Reference Number: City of Sultan Wastewater Treatment Facility Upgrade

District DR Number: 21-10-363

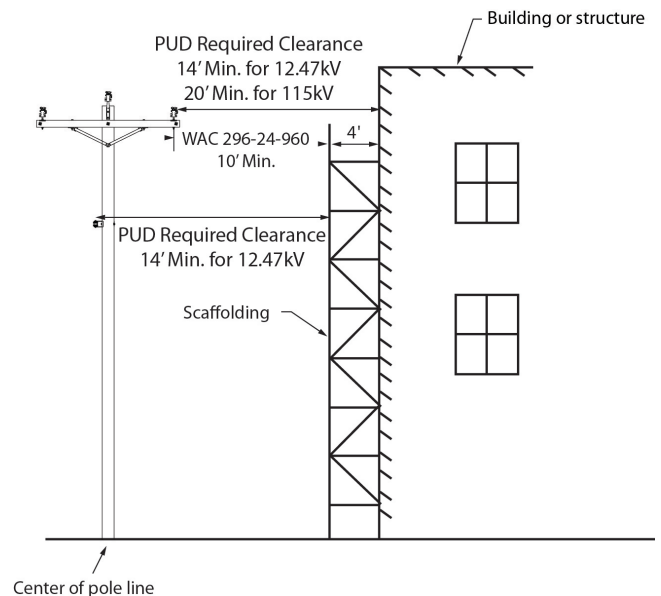
The District presently has enough electric system capacity to serve the proposed development. However, the existing District facilities in the local area may require upgrading. Cost of any work, new or upgrade, to existing facilities that is required to connect this proposed development to the District electric system shall be in accordance with the applicable District policy. The developer will be required to supply the District with suitable locations/easements upon its property for any electrical facilities that must be installed to serve the proposed development. It is unlikely that easements will be granted on District-owned property, or consents granted within District transmission line corridors.

Please be advised that per WAC 296-24-960 the minimum worker safety clearance from any District distribution conductor is 10 feet. **Therefore, the District requires a minimum 14-foot clearance from any structure to accommodate workers, scaffolding and ladders. Minimum worker safety clearance from 115kV transmission wires is 20 feet.**

PUD transmission staff will need to review for conflicts and possible relocation. Any relocation, removal or undergrounding of District facilities to accommodate this project and the worker safety clearances shall be at the expense of the project developer and must be coordinated with the PUD in advance of final design. Please include any project related utility work in all applicable permits.
